## COLORADO GEOLOGICAL SURVEY

Subject: Douglas Mountain Ranch – Rezoning to Planned Development and Boundary Line Adjustment

RZ2018-0001 and AX2018-0003; Clear Creek County, CO; CGS Unique No. CL-19-0001

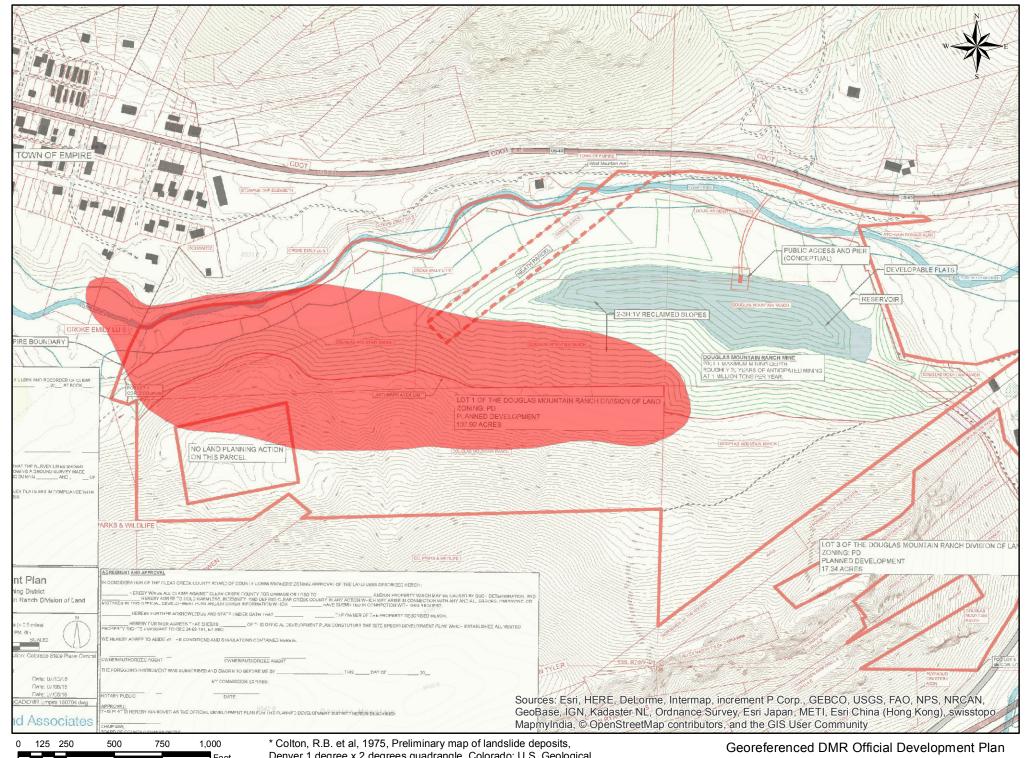
**Mapped landslide and risk of landslide reactivation.** The eastern and southeastern portion of the proposed sand and gravel extraction area is located in the lower half, or toe area, of a large mapped landslide (Colton, R.B., Holligan, J.A., and Anderson, L.W., 1975, Preliminary map of landslide deposits, Denver 1 degree x 2 degrees quadrangle, Colorado: U.S. Geological Survey, Miscellaneous Field Studies Map MF-705, scale 1:250,000.) See map on page 3 of this letter.

shallower, and will take place on the alluvial terrace, not up on the potentially unstable slopes of the mountainside." The map attached to this letter shows that **proposed extraction encroaches into the mapped landslide area.**

It is not possible to determine the probability or predict the magnitude of future landslide activity, and stabilization of a landslide complex this large would be impractical. Avoidance is the preferred mitigation for landslides, and CGS strongly discourages grading and development within and below identified and potential landslide areas. Even if the proposed final (reclaimed) slopes were analyzed and determined to be locally stable, removal of toe material would significantly increase the risk that seismic activity or an exceptionally heavy or prolonged rainfall or snowmelt event could cause destabilization and slope movement of unknown extent and magnitude.
